SUBJECT: Beaver Valley Power Station - Unit No. 2
Docket No. 50-412
Response to Draft SER Open Item 178

Draft SER Open Item No. 178 (Section 2.5.4.3.4) - Densification of Soils (Liquefaction analysis of soils in the vicinity of the intake structure and sliding stability analysis for the intake structure):

CHECKED <i>gwm</i>		TITLE Fig. 2.5.4-65 Main Intake Structure Dynamic Sliding Stability	SCALE: NTS
CORRECT			DATE: 8-30-84
APPROVED			SKETCH NUMBER

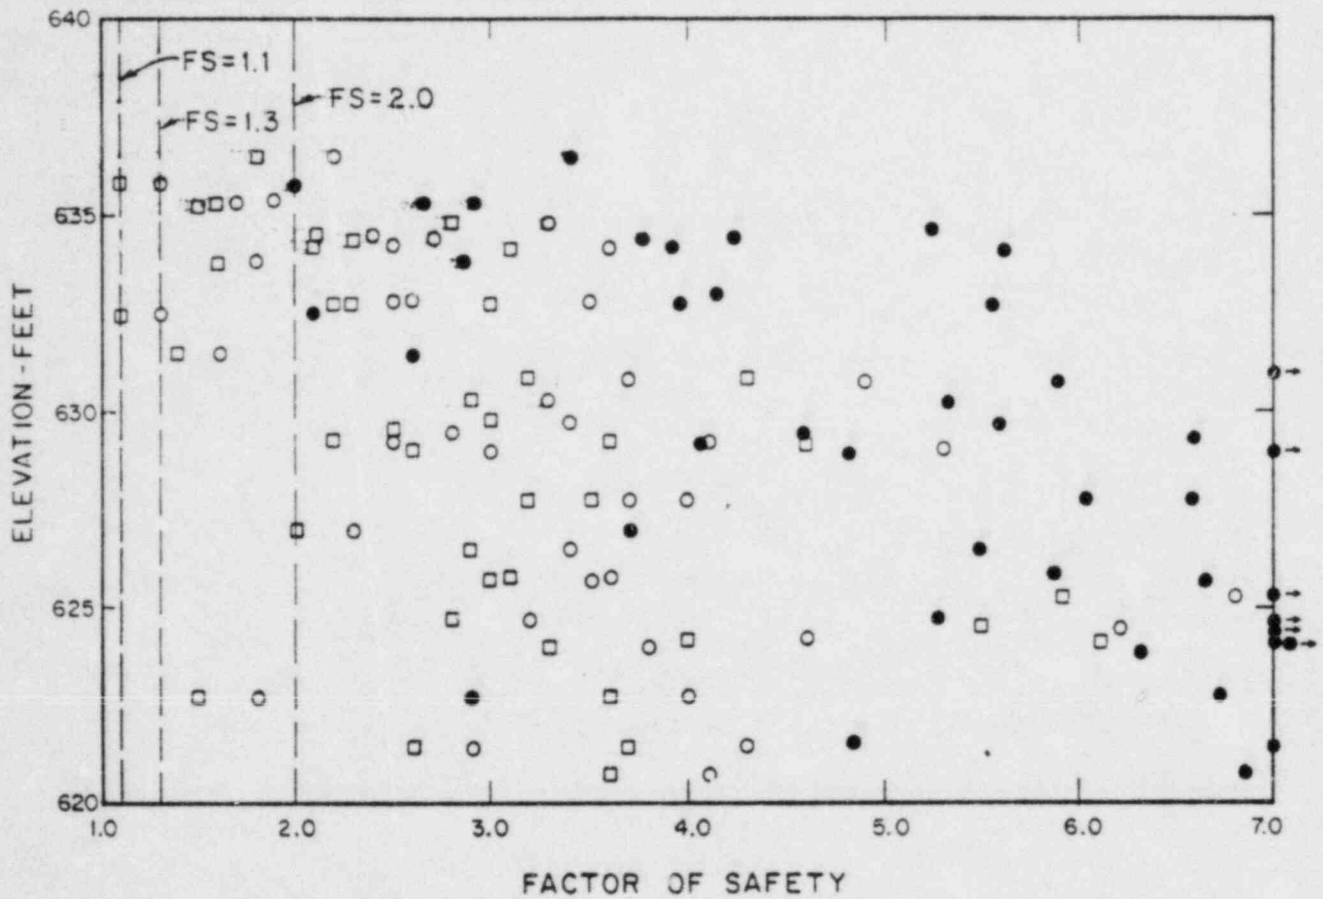
The applicant has also performed, but not yet docketed, a sliding stability analysis for the intake structure. In addition to this analysis, the applicant must also reevaluate and docket the liquefaction potential analysis of the soils beneath, and east, and west of the intake for the combination of OBE and a ground water level corresponding to the standard project flood (el. 705 ft) as recommended by SRP 2.4.4.

Figure 2.5.4-65 presents the loading diagram used to calculate the factor of safety against sliding of the main intake structure. The water level within the intake structure is the same as the river level. During plant operation a maximum of one bay can be dewatered which would reduce the frictional resisting force along the base of the structure. During a seismic event, undrained shear behavior will govern sliding stability of the intake structure. Changes in vertical stresses at the soil-structure interface will cause a corresponding change in pore pressure. Therefore, the effective contact pressure will remain constant and equal to the effective building weight (total building weight minus static buoyant force). Consequently, only the horizontal component of interial force is considered in the sliding stability analysis. Under the conservative conditions of the SSE, standard project flood, and one intake bay empty, the factor of safety against sliding is 1.3 which is satisfactory. The dynamic sliding stability analysis of the intake structure was conservatively performed without taking into account passive resistance of the soil.
